JOINT REGIONAL PLANNING PANEL (Hunter and Central Coast)

Council Assessment Report

Panel Reference	PPSHCC-37
DA Number	DA/163/2020
Local Government Area	Central Coast Council
Proposed Development	Seniors housing facility comprising 199 residential units, community facilities & associated works
Street Address	Lot 1 DP 373539, 125 Johns Road, Lot 1169 DP 812203, 135 Johns Road and Lot 1168 DP 812203, 95 Murrawal Road, Wadalba
Applicant	ADW Johnson Pty Ltd
Owner	Tocae Group
Date of DA Lodgement	28 February 2020
Number of Submissions	Three
Recommendation	Refusal
Regional Development Criteria - Schedule 7 of the State Environment Planning Policy (State and Regional Development) 2011	The application is declared to be Regionally Significant development in accordance with clause 20(1) of <i>State Environmental Planning Policy (State & Regional Development) 2011</i> as it is development that has a capital investment value of more than \$30 million.
List of all relevant 4.15(1)(a) matters	<ul style="list-style-type: none"> • <i>Environmental Planning & Assessment Act 1979</i> (EP&A Act) • <i>Environmental Planning & Assessment Regulation 2000</i> (EP&A Regulation) • <i>Rural Fires Act 1997

Figure 8 Sewerage Arrangements

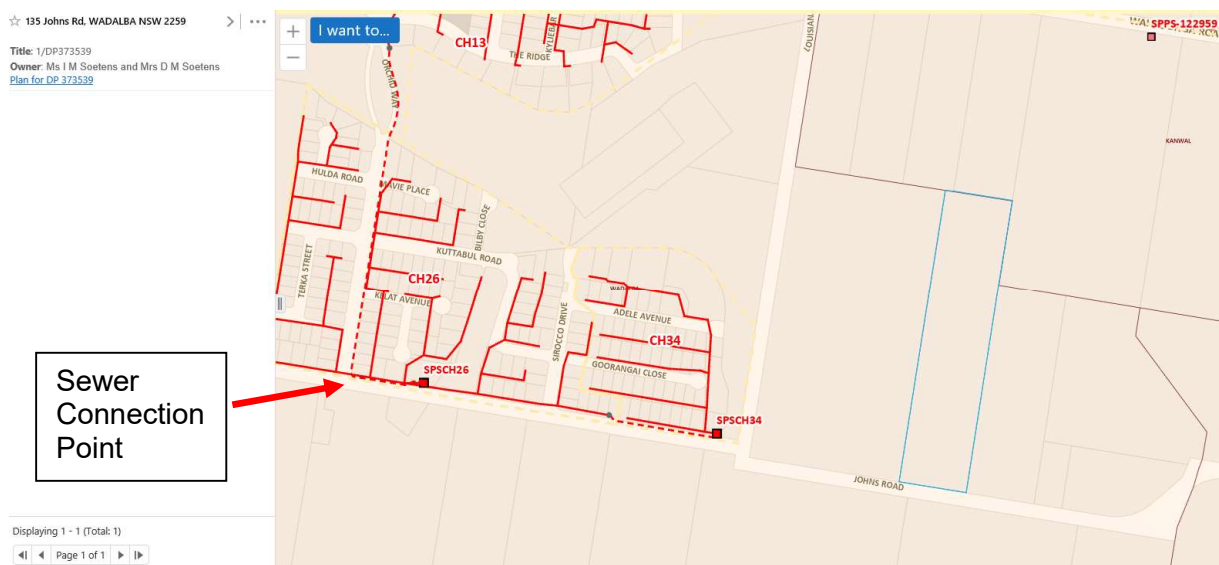
The site is currently not connected into Council's sewer network. The nearest existing Council sewer network is located at 139 Johns Road (sewerage pump station SPSCH34). This existing sewerage pumping station will reach its capacity once the adjoining subdivision development at 137 Johns Road (DA/1419/2017) occurs. The connection of the adjoining residential subdivision to SPSCH34 is the subject of a Voluntary Planning Agreement relating to DA/1419/2017.

The seniors living development is required to gravitate to a (private) temporary pump station on the site and to construct a rising (pressure) main that connects to Council's existing rising main in the road reserve near the Orchard Way and Johns Road intersection (CH26). It is not known whether there is sufficient service allocation available in the road reserve to accommodate the additional rising main, given that the approved subdivision development to the west of the site will also utilise the road reserve in this way. Additionally, the proposal must make provision that the site's catchment can be gravitated into the regional catchment further to the east of Murrawal Road (CH33 in the below diagram).

Figure 10 Location of green corridors and local conservation links as identified in the North Wyong Structure Plan.

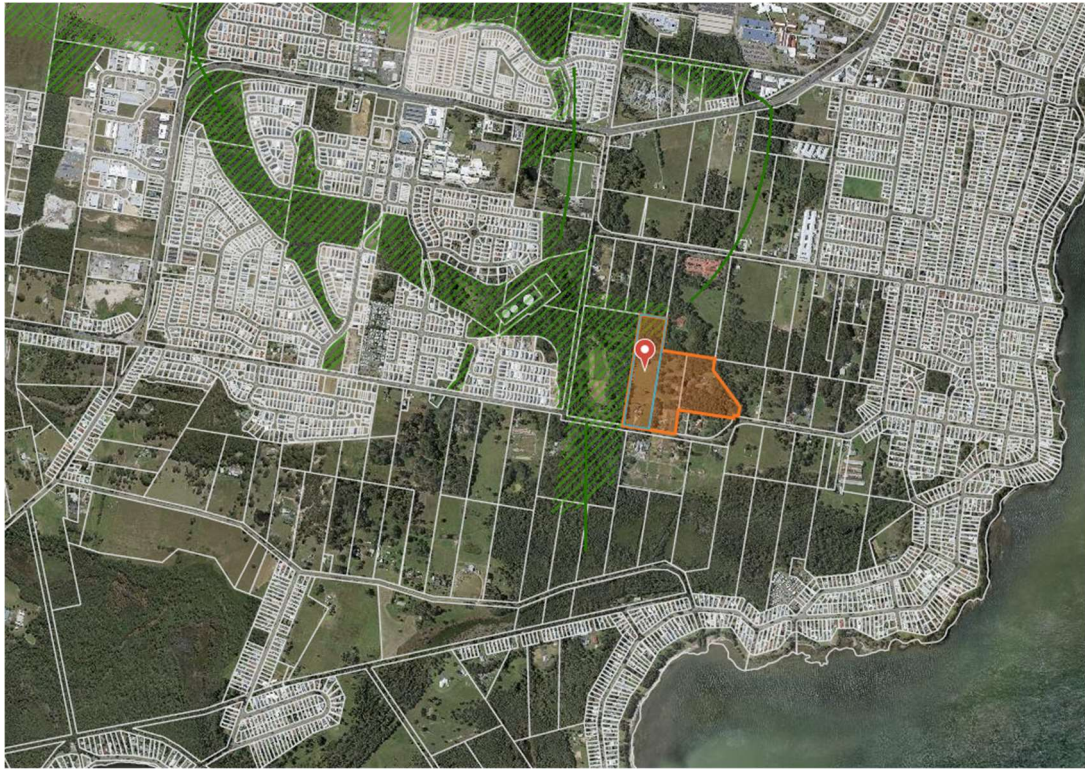
The northernmost extent of the site (an area of 1.2ha) is mapped green corridor and the vegetation in this area is proposed for retention without modification.

Figure 12: Extract of engineering plans showing location of detention basin within Johns Road frontage and the height of associated retaining walls

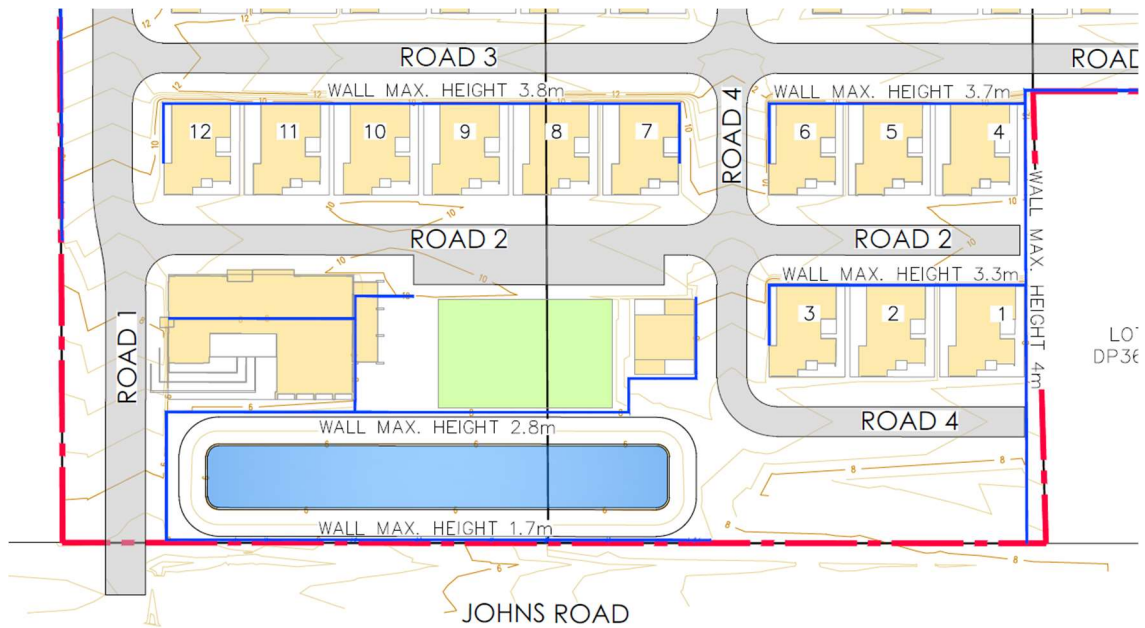
In addition, the excessive height of retaining wall structures required for stormwater detention and their proximity to both Johns Road and neighbouring properties (particularly Lot A DP370424) is not supported. Detention basin walls with heights of 1.7 – 2.8 metres (dry detention basin) are located within the Johns Road frontage as indicated by the engineering plans (extract provided below).

Figure 13 extract of engineering plans showing location of detention basin within the site and the height of associated retaining walls in proximity to the neighbour.

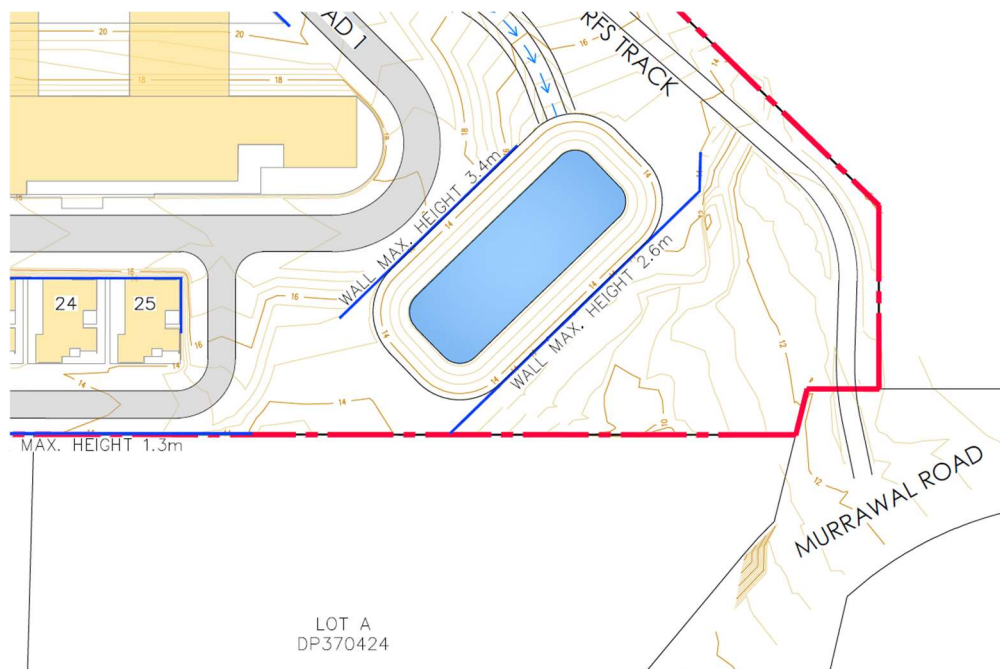
A detention basin to the east of the site has a retaining wall height of 2.6 metres at the property boundary with the eastern neighbour. This is an unacceptable visual outcome that is incongruous both with the existing rural land uses and future land uses anticipated under the North Wyong Shire Structure Plan. On this large site it is considered that there are sufficient opportunities to provide more sensitive relationships to neighbouring properties. An extract from the engineering plans depicting the detention basin location and heights of retaining walls is provided below.

Figure 14: Elevations of the Hostel building

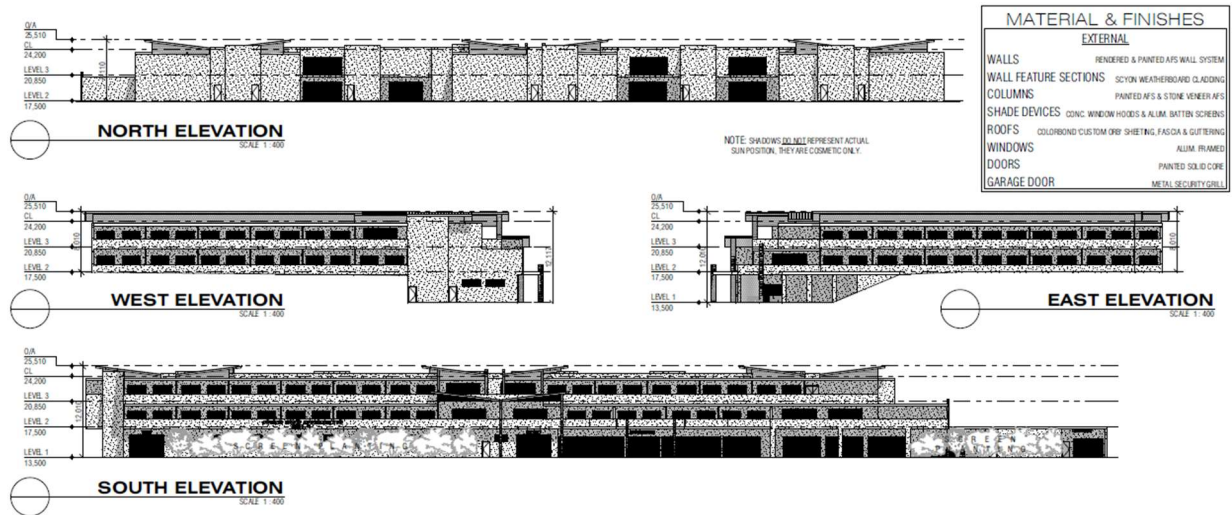
The hostel building has elevations in the order of 113 metres (three storeys) and 56 metres (two to three storeys). These elevations are largely unarticulated, with repetitive window placement and little variation. This does not represent an appropriate residential character within the rural/low density residential context of the site. The building configuration reflects the hostel nature; however the external elevations of the buildings are not modulated with groups of units projecting forward along the façade to break up the long repetitive form and provide an appropriate residential character.

Figure 17: Extract of landscape plan showing replacement planting

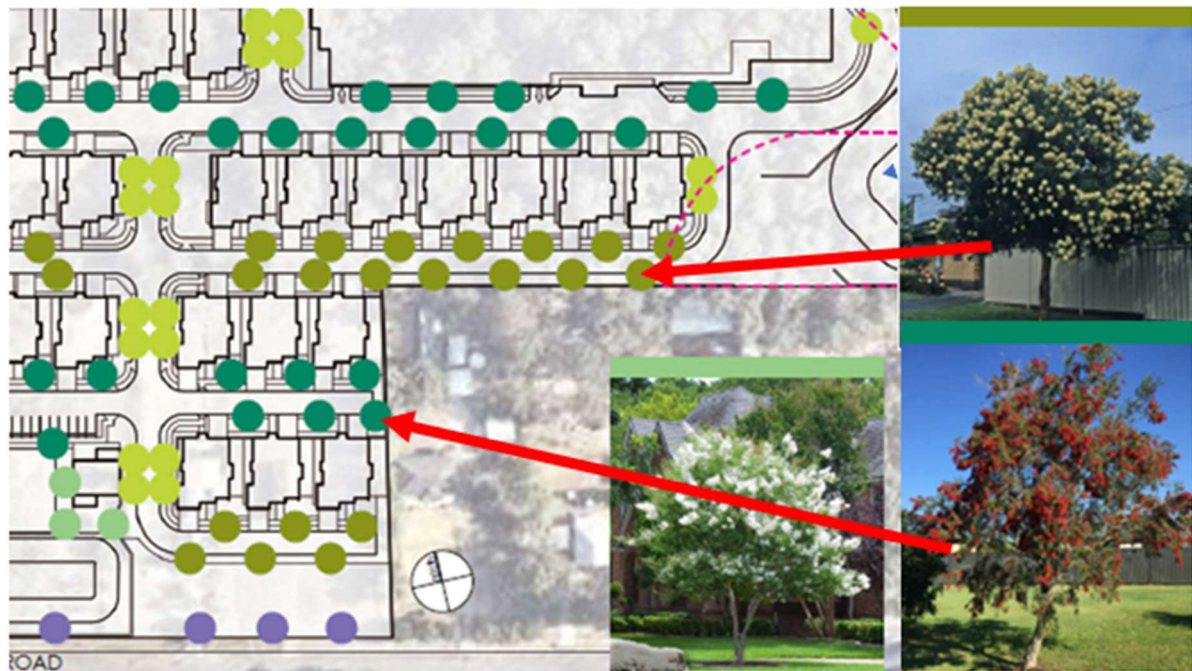
The proposal provides inadequate replacement planting that has limited, if any, value in mitigating privacy impacts of the development or the amenity impacts to the outlook of neighbouring properties resulting from the loss of vegetation. Intermittent planting of *Corymbia eximia* "nana" (Dwarf Yellow Bloodwood) and *Callistemon viminalis* (Weeping Bottlebrush) that achieve a height of approximately 6 to 8 metres at maturity are proposed to be planted within proximity to the boundary with affected neighbours however, as a result of altered ground levels proposed at the boundary, the new tree planting is proposed at a significantly lower finished ground level in the order of 3 to 5 metres below the level of neighbouring properties.

Figure 19: Partial extract showing 9am, 12 noon and 3pm shadow impacts to serviced housing dwellings

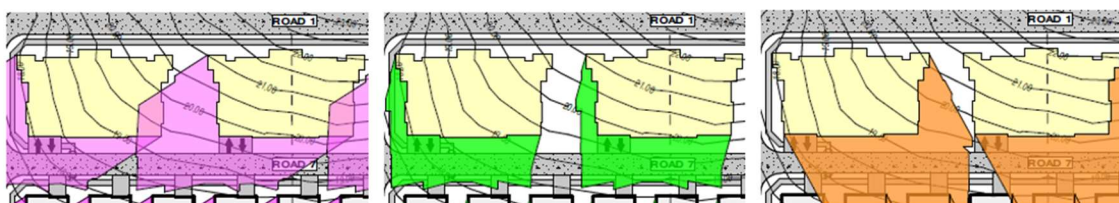
- a) Serviced housing units within the residential flat buildings do not have adequate (if any) solar access to primary living spaces or private open space (POS) areas. All units have south facing living spaces and private open space, with 4 out of 8 units having either an additional easterly or westerly orientation. Units with an easterly orientation receive limited benefit due to shadowing from adjoining flat buildings at 9am, and at 12 noon the angle of the sun is very oblique to window openings. The shadow diagrams do not accurately show solar impacts of high retaining walls and level changes across the site.

Figure 21: Partial extract showing 9am, 12 noon and 3pm shadow impacts to serviced housing dwellings

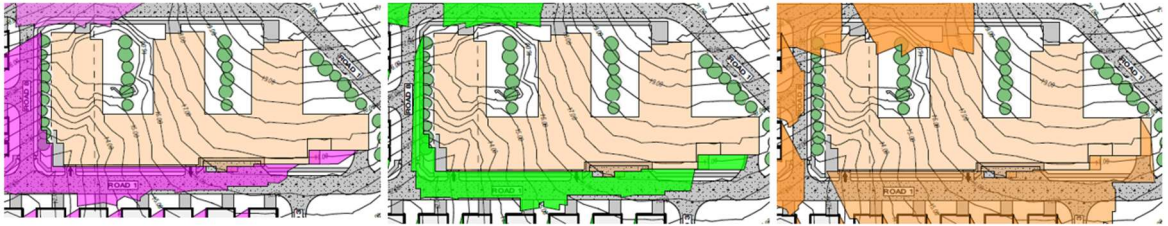
- c) The hostel building does not have living and dining areas that are located with a northerly orientation. The north façade of the building has few windows. There are

missed opportunities at the northern extent of the wings of the buildings. The Level 2 floor plan does not provide a meaningful connection to the courtyard garden spaces that are flanked by the wings of the building. Lounge areas and terraces could provide opportunities to enter these north facing gardens for passive recreation. These areas could provide good opportunity for level, sheltered and secure outdoor spaces for residents. The hostel building has south facing dining, courtyard, lounge and terrace communal open space areas. Some areas such as upper level terraces have limited access to easterly orientation. The submitted shadow diagrams do not show the impacts of the "wings" of the hostel building at 9am and 3pm to internalised garden courtyard spaces.
